### **REMARKS**

### **Drawings**

Red-lined drawings are attached hereto, as shown:

FIG. 3B

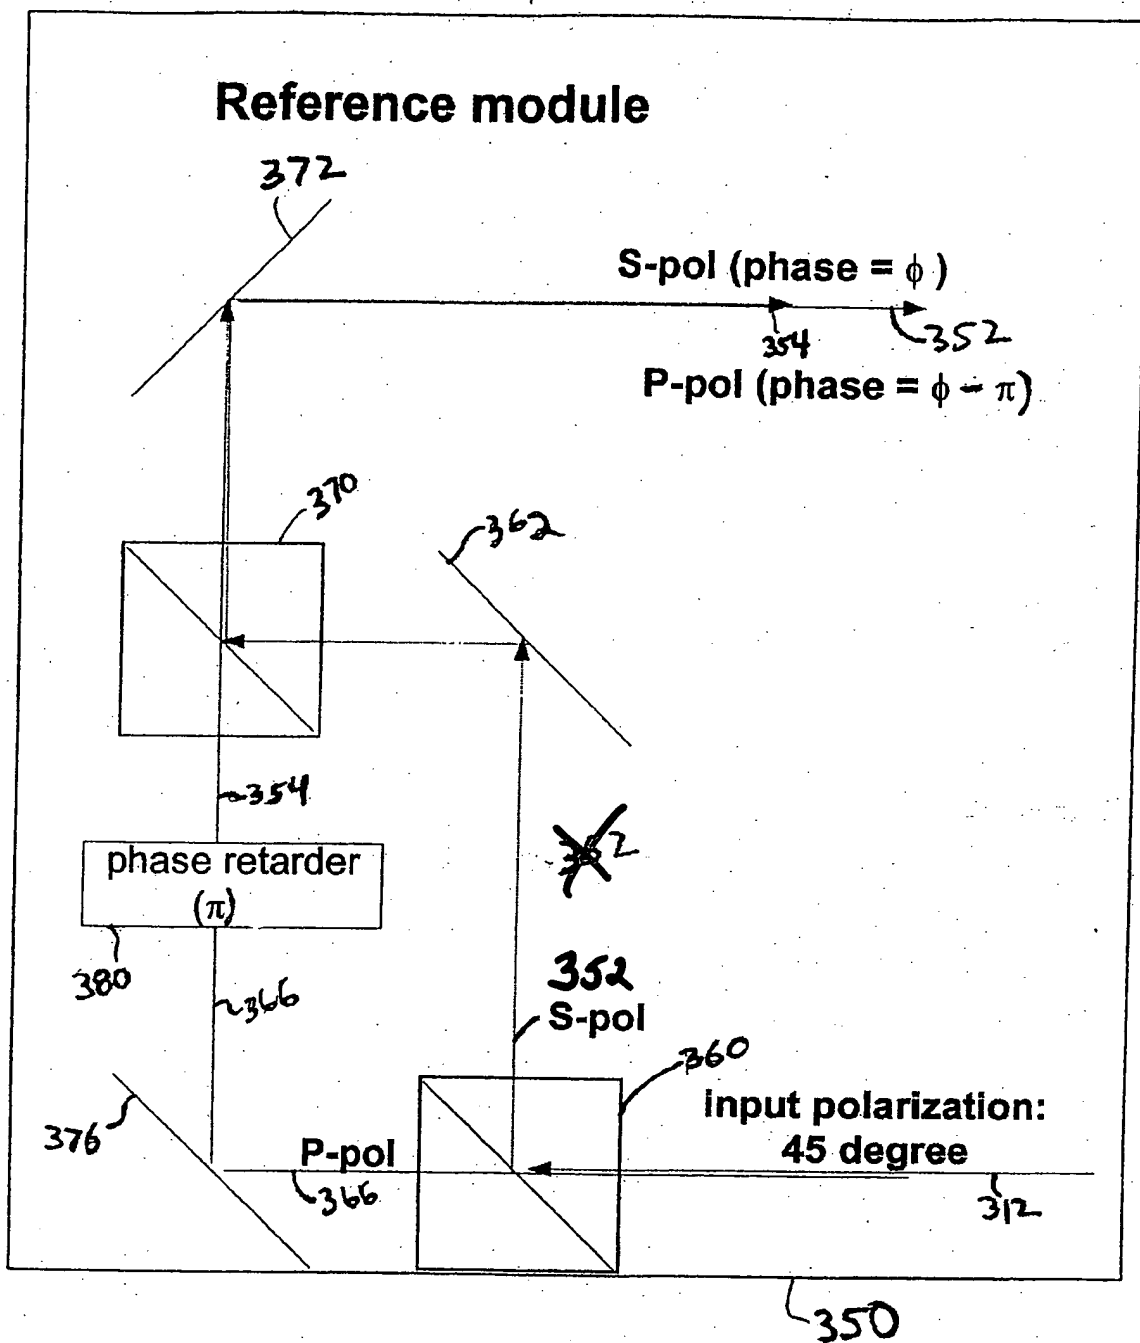
FIG. 3B (sheet 4/13) more closely places element number 352 to S-pol;

FIG. 6C

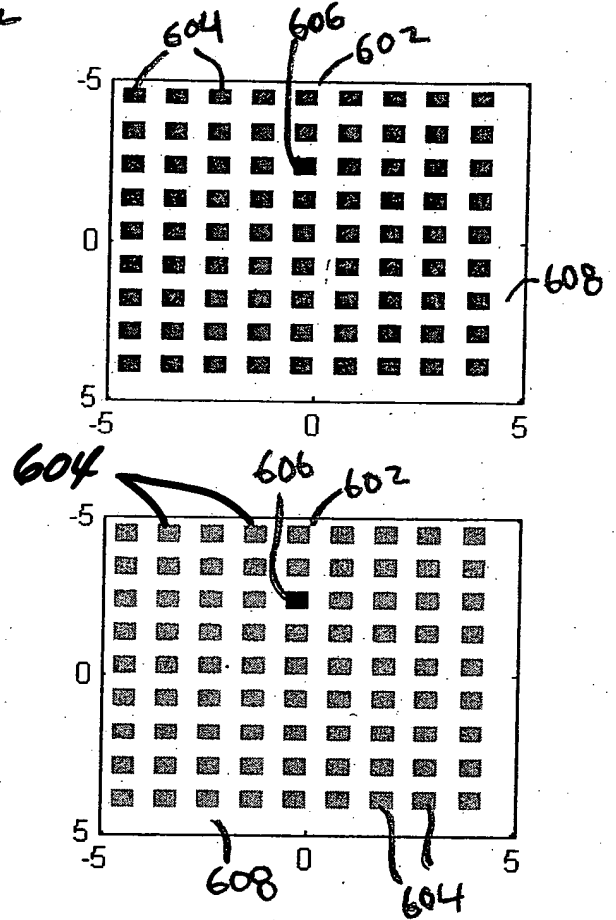
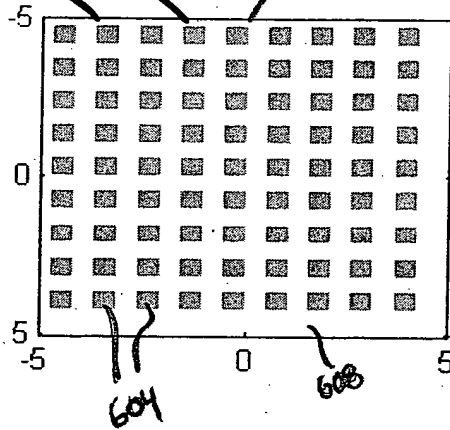
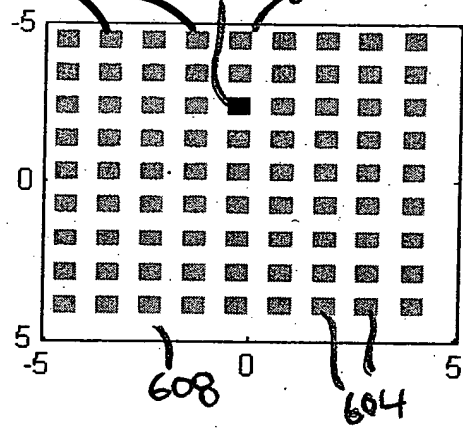
FIGs. 6C and 6D (sheet 7/13) add the element numbers 604 and their respective lead lines;

FIG. 8

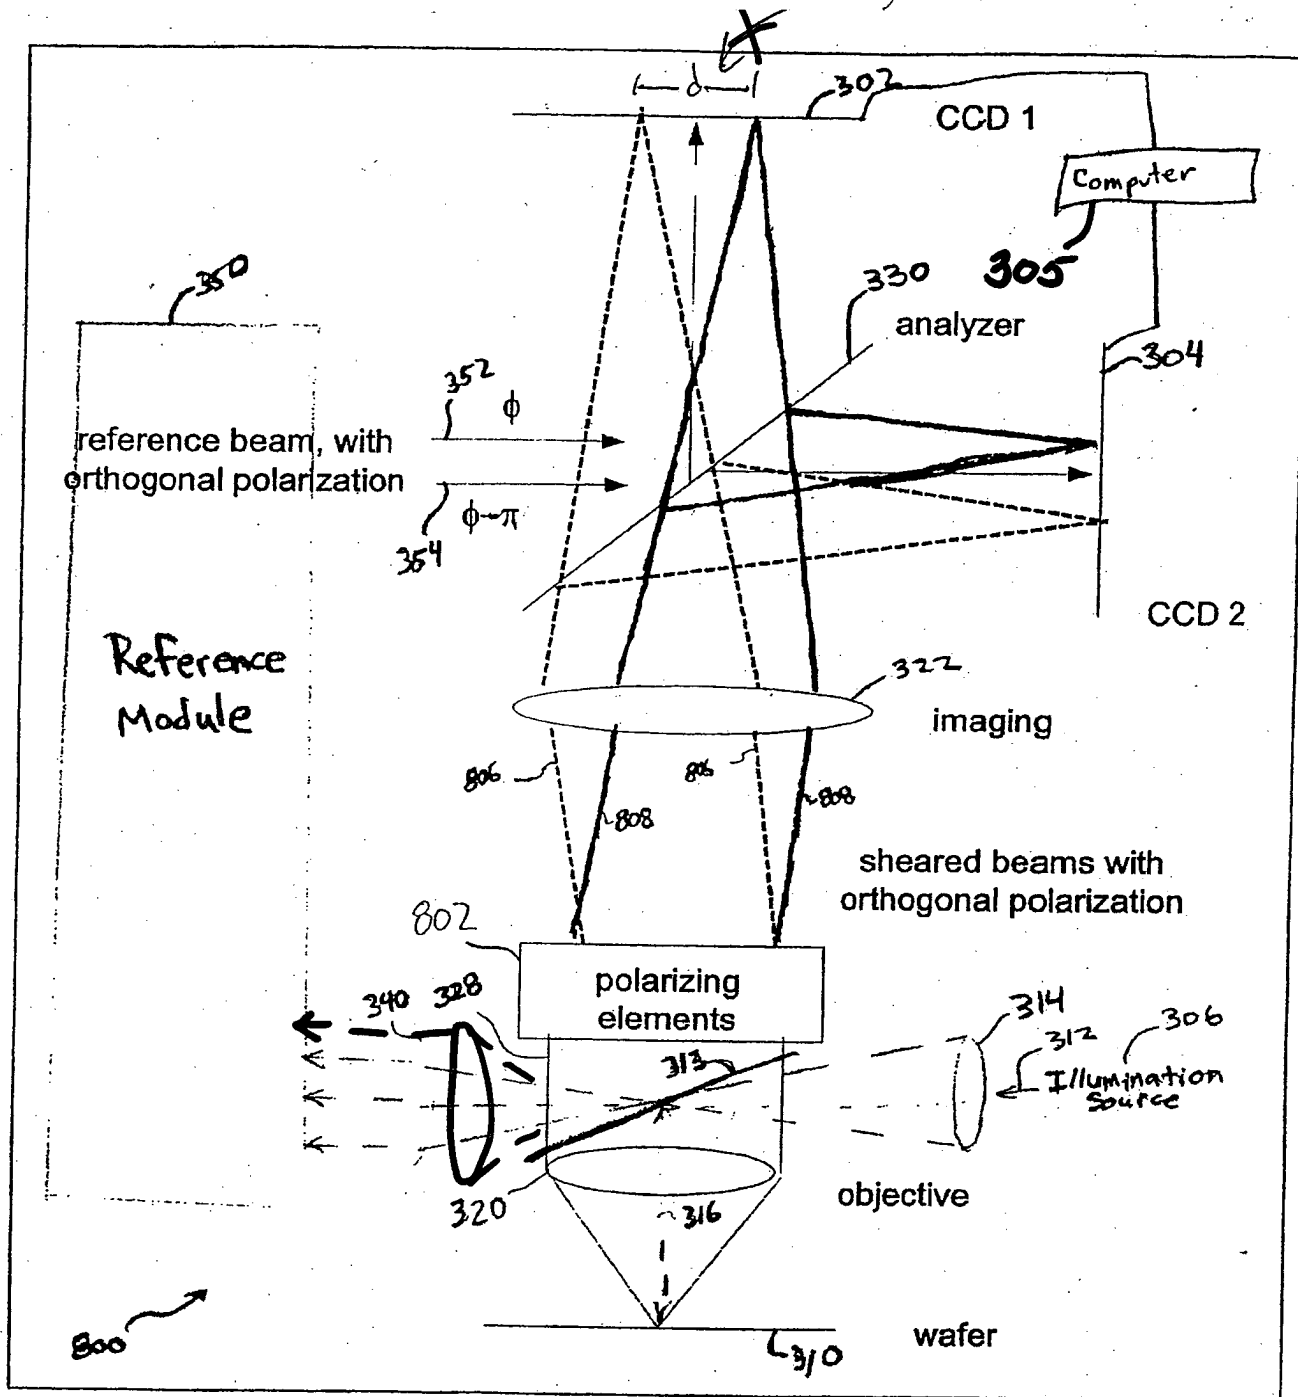
FIG. 8 (sheet 8/13) shows an element 340 that is shown faintly in the original drawings as filed.

Figure 12C. The simulated signal plot at the CCD through differential interference detection. The object in ~~the~~ simulation is illustrated in Figure 7.

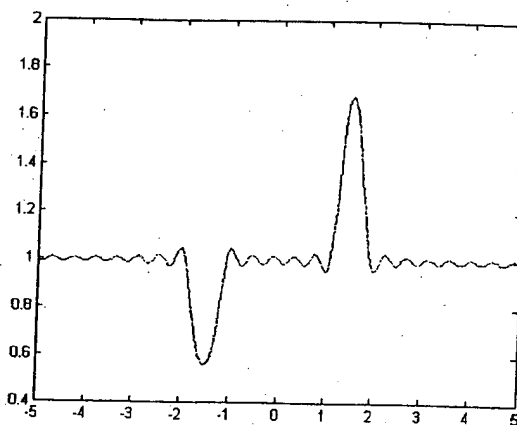
FIG. 12C (sheet 13/13) deletes the extraneous word "is" in the text as shown.
